Product: Cluster	Description: Changes to the Bayliner Capri and Bayliner Maxum Wire Harness	Date Jan 08
Type: Electric		1

To eliminate damage to the mode and adjust input circuitry it is necessary to make a simple change to the wire harness.

This change is REQUIRED for all Capri/Maxum boats that use the VDO Instrument Cluster

Figure 1 – Current Location of the “Ring Terminal Ground”

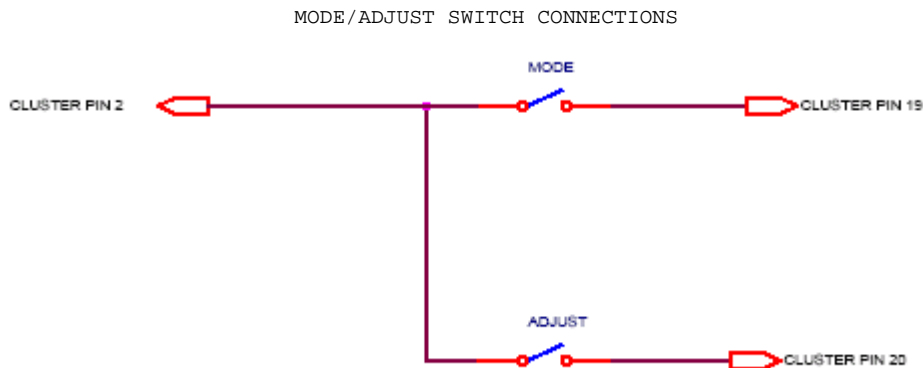
The instrument cluster ground is currently connected via a ground wire with a large ring terminal that is intended to go to the negative terminal of the battery. (See Figure 1) As long as this connection is constantly maintained there is no problem. If this ground connection becomes intermittent, or is not connected, the cluster can seek ground through the mode/adjust switches. This causes the mode/adjust switch isolation diodes to fail due to excessive current if at the time the cluster lighting is turned on.

The main instrument cluster ground is pin 4. It is highly recommended that the ring terminal that presently connects directly to the battery negative be replaced with a smaller ring terminal that is compatible with the ground buss bar and re-terminated at the buss bar. This buss bar is located near the battery. (See Figure 2) This will eliminate the problem of not connecting or improperly connecting the instrument cluster ground.

Figure 3 – Current grounding method for the Mode/Adjust switches. Note the Yellow wires labeled 8 and 11. These are the ground wires.

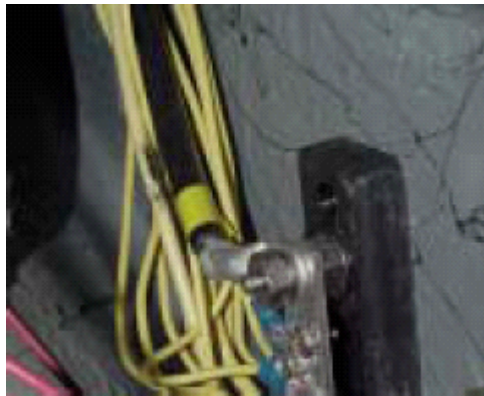
In order to eliminate this problem it must be assured that only one grounding point exists for the cluster under all operating conditions. This can be done by returning the ground for the mode and adjust switches only to the cluster ground at pin 2. The Capri boat that we have used for testing has two grounds connected to the mode/adjust switches. These wires are labeled 8 and 11 (See Figure 3). These ground connections should be disconnected from the switches (taped off and/or clipped) and replaced by a jumper that connects two switches together (where the 8 and 11 ground wires were removed) and then using a single wire connected with a female AMP pin to pin 2 of the instrument cluster. (See Figures 4,5 and 6) Currently there should be no wires connected to this pin. See the schematic below and associated pictures for more detail.

Figure 6 – This is the 24 Pin Connector located on the rear of the Instrument Cluster. The White wire next to the small blue wire is connected to pin 2. This is the new location for the ground wire for the Mode and Adjust Switches.

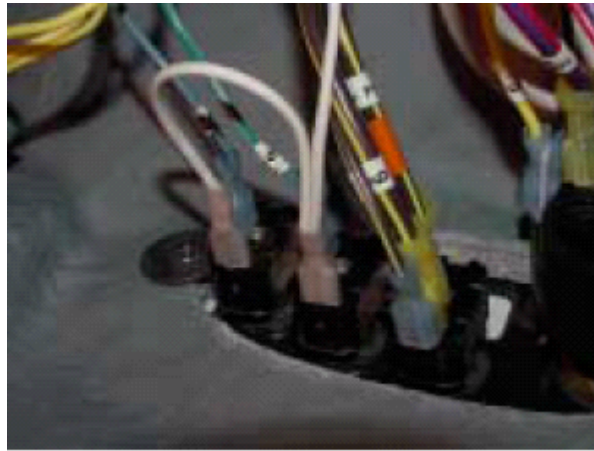
Note: Disconnect the rear 24 pin connector (as shown in Figure 6) plug from the instrument cluster before making any wiring changes! Reconnect the cluster only after all wiring has been verified to be correct.
